Request	-	Special Use Permit for a New Gas Station
Location	-	3837 Secor Road
Applicant / Developer	-	Skilkengold Development, LLC 4270 Morse Rd Columbus, OH 43230
Owner	-	Sheetz, Inc. 5700 Sixth Ave Altoona, PA 16602
Engineer	-	Mannik & Smith Group 1160 Dublin Road, Suite 100 Columbus, OH 43215

The staff recommends that the Toledo City Plan Commission recommend disapproval of SUP-5009-24, a Special Use Permit for a new gas station at 3837 Secor Road, to the Toledo City Council, for the following five (5) reasons:

SPECIAL USE PERMIT
TOLEDO CITY PLAN COMMISSION
REF: SUP-5009-24
DATE: August 8, 2024
TIME: 2:00 P.M.

SITE PLAN

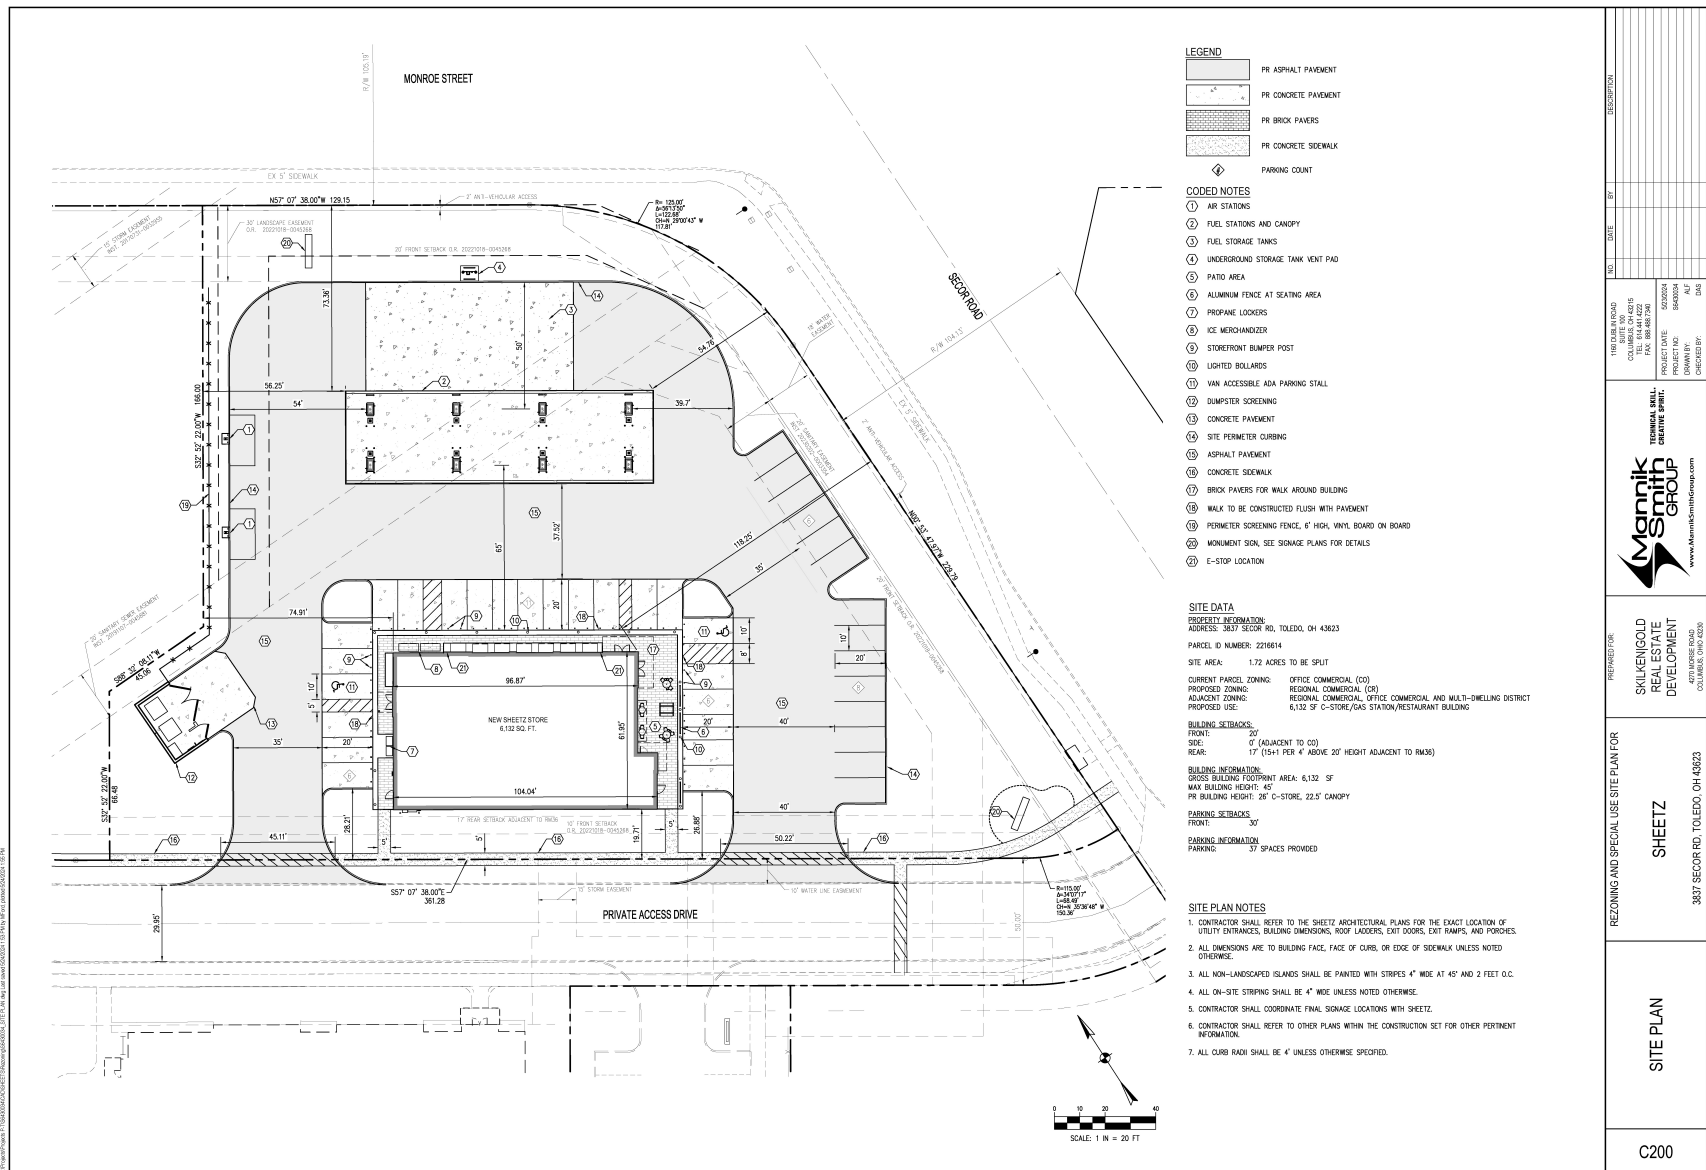
A front yard setback must be provided along private access drives. Per TMC§1106.0102, a front yard setback of twenty feet (20') is required. A setback of 19.71 feet is provided along the private access drive. A revised site plan showing compliance with this setback shall be provided. This has been listed as a condition in Exhibit "A".

This property has been recorded as part of a plat titled Secor Crossings. The Secor Crossings plat shows a landscape easement of thirty feet (30') along the rights of way of Monroe Street and Secor Road. The site plan shows this easement along Monroe Street, but does not show it along Secor Road. As a result, the parking lot encroaches into the easement by ten feet (10'). A revised site plan showing this landscape easement free of encroachments shall be provided. This has been listed as a condition in Exhibit "A".

TMC§1107.1600 *Vehicle Stacking Areas* outlines design standards for gas pump stacking spaces. A revised site plan showing required stacking spaces shall be provided. This has been listed as a condition in Exhibit "A".

A minimum of one (1) bicycle parking space per ten (10) automobile parking spaces is required pursuant to TMC§1107.0300 *Off-Street Parking Schedule "A"*. The site plan provides zero (0) bicycle parking spaces and is therefore not in compliance. Five (5) spaces are required and shall be provided on a revised site plan. Bicycle parking must be well-lighted, paved, and drained to be reasonably free of mud, dust, and standing water. These have been listed as conditions in Exhibit "A".

32. Bicycle parking is required per TMC§1107.0900.
33. Gas pump stacking is required to be shown per TMC§1107.1601.
34. Accessible parking signage is required to be shown and must comply with TMC§1107.1704
35. Gas pumps must be moved 3' to the northeast to allow room for a two-way drive aisle with the gas pump stacking per TMC§1109.1911 (25' drive aisle is required for two-way traffic).
36. A smaller radius of the parking lot northeast of the gas pumps is required to prevent a pinch point of traffic flow.

- a. A twenty-foot (20') front yard setback shall be provided along the private access drive. **Not acceptable as depicted. A revised landscaping plan shall be submitted depicting the twenty-foot (20') front yard setback along the private drive.**

- b. Stacking spaces required by TMC§1107.1600 *Vehicle stacking areas* shall be depicted. Stacking spaces shall show compliance with TMC§1107.1600. **Not acceptable as depicted.**

- c. A thirty-foot (30') landscape easement shall be shown identical to the landscape easement shown on the Secor Crossings Plat. Said landscape easement shall be extensively landscaped adhering to the provisions of TMC§1108.0202 *Frontage Greenbelt*. The landscape easement may not contain off-street parking facilities, including vehicular drives and maneuvering areas. **Not acceptable as depicted. The thirty-foot (30') landscape easement shall be shown and the off-street parking area must not encroach upon said easement.**

- a. A 5-foot-wide connecting walkway shall be provided from at least one main entrance to the intersection of Monroe Street and Secor Road without requiring pedestrians to walk around buildings or around parking lot outlines which are not aligned to a logical route. **Not acceptable as depicted. A revised site plan shall be submitted depicting a connecting walkway to the intersection of Monroe and Secor.**

- 50. Two (2) speed tables shall be required on the private access drive. Locations shall be approved by the Division of Traffic Management and the Director of the Toledo City Plan Commission. **Not acceptable as depicted. Speed tables in approved locations shall be depicted on a revised site plan.**

STORE LANDSCAPE PLAN

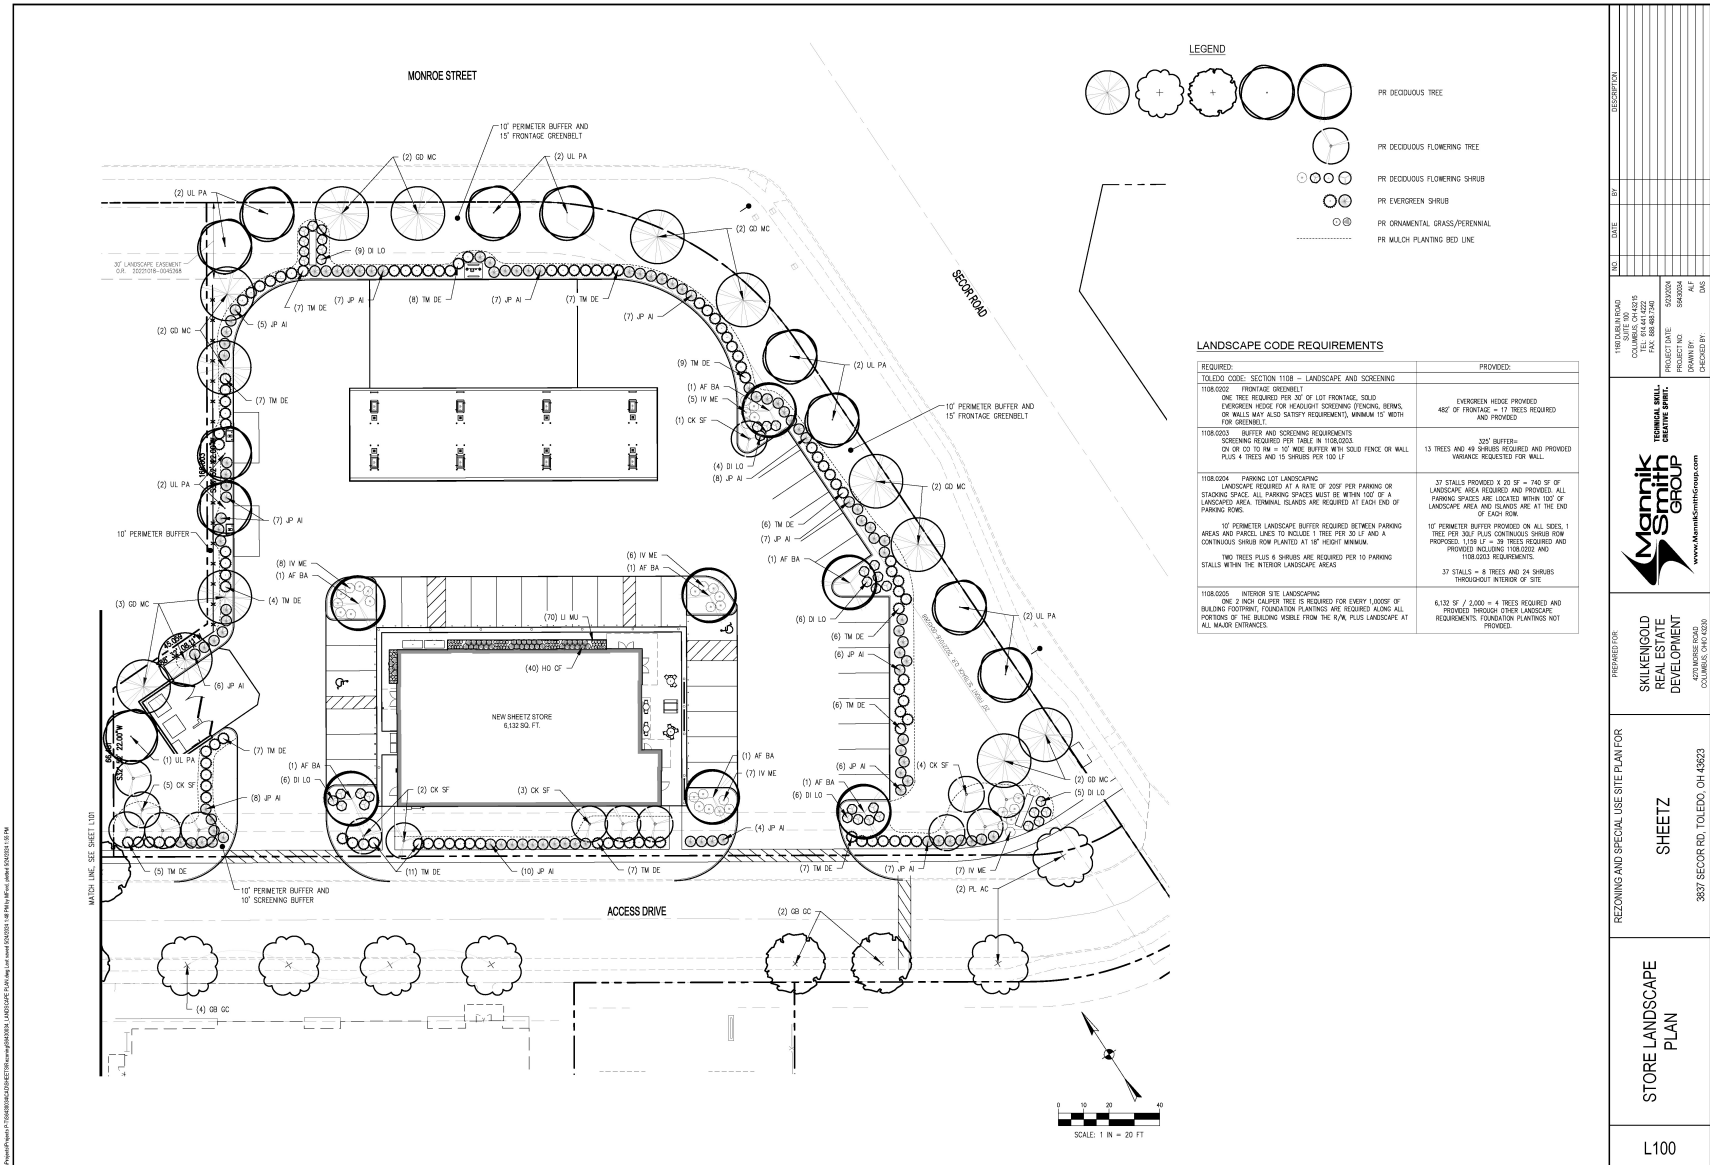
TMC§1108.0204(C)(1) *Interior* requires two (2) canopy trees and six (6) shrubs in the interior of parking lots for each ten (10) parking spaces, rounded up. The site plan provides forty-five (45) parking spaces, meaning ten (10) trees are required in the parking lot interior. However, the submitted landscaping plan depicts only eight (8) trees in the parking lot interior. Two (2) additional trees are required and shall be provided. This has been listed as a condition in Exhibit “A”.

- e. Two (2) canopy trees and six (6) shrubs are required to be installed in interior landscape areas for each ten (10) parking spaces within the parking lot. A total of ten (10) trees and thirty (30) shrubs are required for this site. **Not acceptable as depicted. Two additional trees required and shall be shown on a revised landscaping plan.**

- g. Foundation plantings shall be required along the portions of the building visible from the right-of-way. **Not acceptable as depicted. Foundation plantings shall be provided along eastern and southern façades and shown on a revised landscaping plan.**

3 REAR ELEVATION
1/8" = 1'-0"

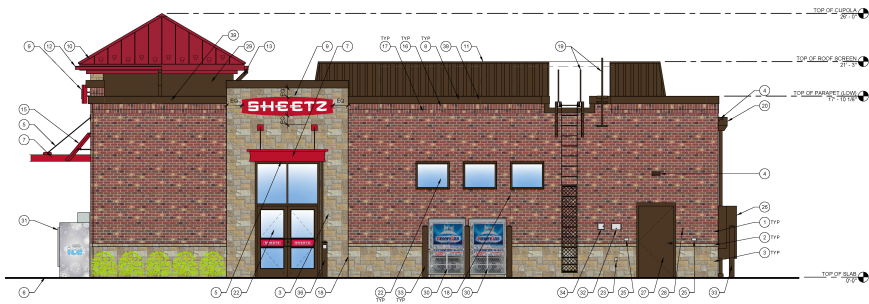
The southern elevation – named the “rear” elevation on the submitted building elevations – faces the senior apartments and pedestrian walkways shown to the south, yet it lacks pedestrian orientation or character. In fact, it lacks any design characteristics consistent with those on the primary façade as required in TMC§1109.0204 & 1109.0205. While the other façades come closer to compliance with the section, they are still missing some variation in massing. As stated in TMC§1109.0205(B)(3), building design that is based on a standardized formula associated with a business or franchise shall be modified if necessary to meet the Design Standards. The proposed building is clearly based upon a standardized formula which has been superimposed onto the site and it is unresponsive to its context near residential apartments in the neighborhood’s park-like setting. The proposal does not meet the stated purpose of these design standards. Revised building elevations shall be submitted in compliance with TMC§1109.0204 & 1109.0205 and listed as a condition in Exhibit “A”.

- b. Southern or “rear” elevation shall be redesigned to be responsive to its context and meet the provisions of TMC§1109.0205 *Building Design Standards*. **Not acceptable as depicted.**

- c. The building design shall provide a well-defined top by using features such as distinct and multiple architectural roof forms, clearly pronounced eaves, and/or distinct parapet designs and cornice treatments. **Not acceptable as depicted on southern or “rear” elevation.**
